October 25, 2016

Subject: Transportation Peer Review Comments
Murphy's Farm Residential Development
Dracut, MA

- *Transportation Impact Assessment, Murphy's Farm Open Space Development, Dracut, Massachusetts, prepared by Vanasse & Associates, dated October 2016.*
- *Preliminary Subdivision Plan, Open Space Development Murphy's Farm, Dracut, Massachusetts, prepared by Andover Consultants Inc., dated June 22, 2016.*

Exhibit 1: Wilshire Circle Northeast Sight Line

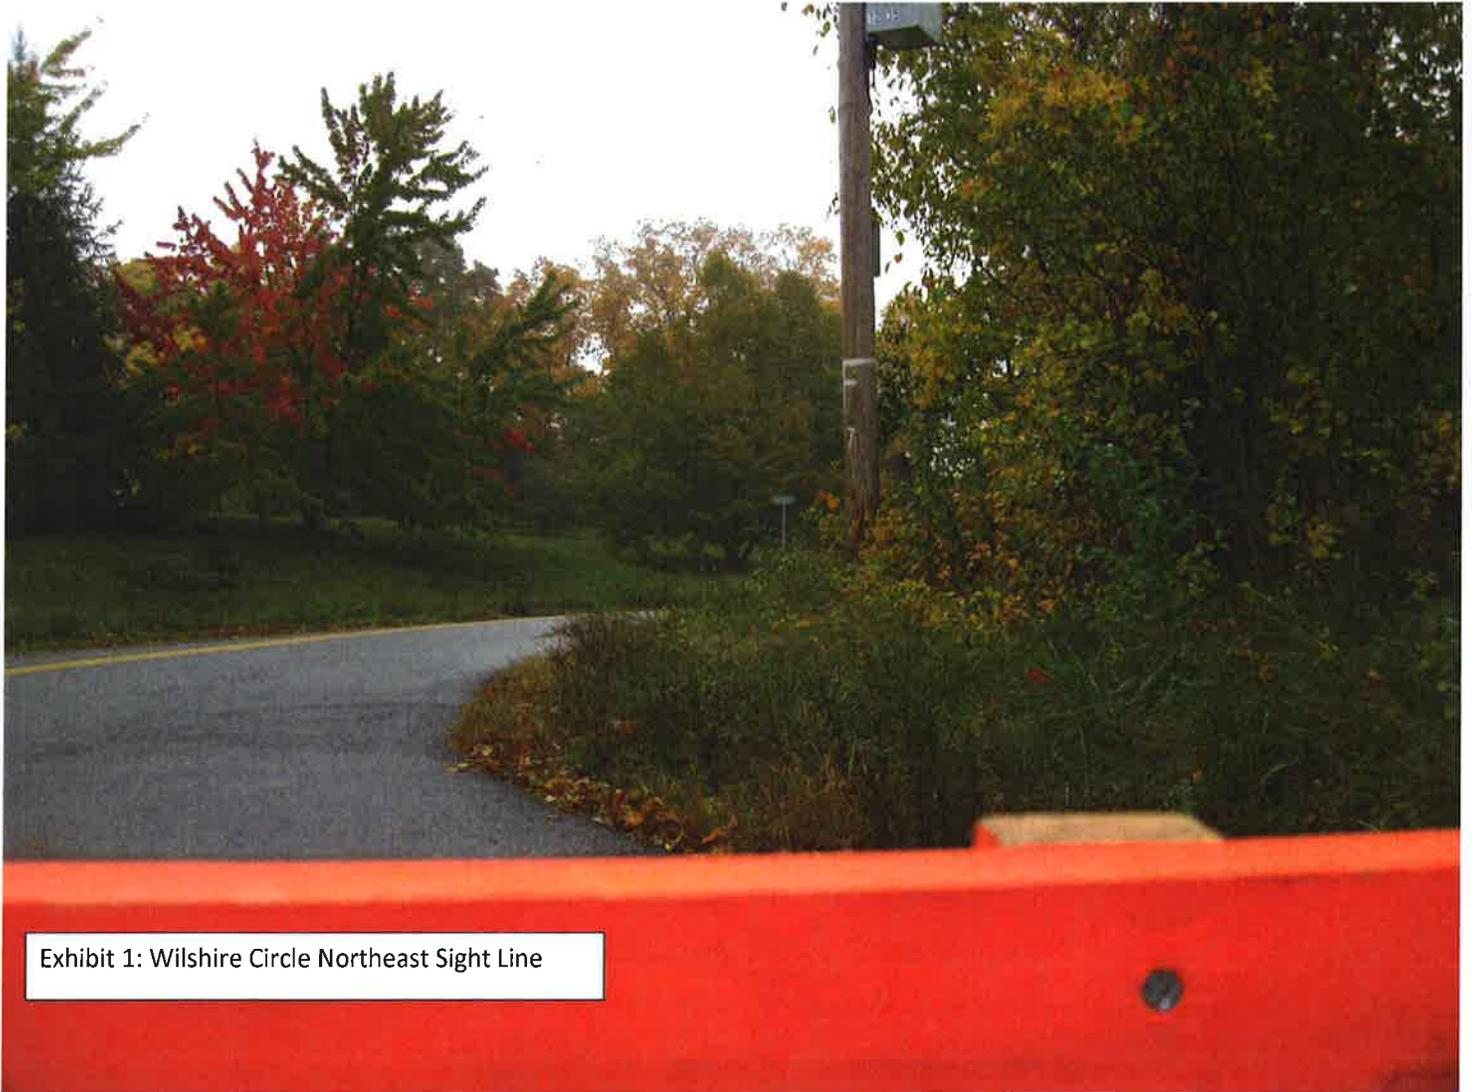
- *Wheeler Road at Wilshire Circle:* MDM's measured sight line looking northeast from Wheeler Road from a stopped position 10-feet from the travel way is 390 feet versus the TIA estimate of 427 feet; however, this sight line is substantially limited (less than 100 feet) when measured from the standard 14.5-foot travel way setback. Intersection sight lines are significantly impaired by vegetation at the northeast corner of the intersection. This sight line limitation may worsen under wintertime conditions, warranting clearing of the vegetation within the sight triangle. See **Exhibit 1: Wilshire Road Northeast Sight Line.**

- *MDM recommends that the applicable sight line triangles be shown for each of the study intersections along with measured sight lines to confirm that minimum sight line criteria are met (305 feet), and if possible the ideal Intersection Sight Distance (ISD) of 385 feet for right turns and 445 feet for left-turns. The sight line triangles should not encroach onto adjoining (private) property to achieve minimum and/or ideal sight line criteria.*

- *MDM recommends clearing of vegetation within public way for sight line triangles at each study intersection, including trimming of branches on trees to a height of 7-feet above ground level to maximize sight lines.*
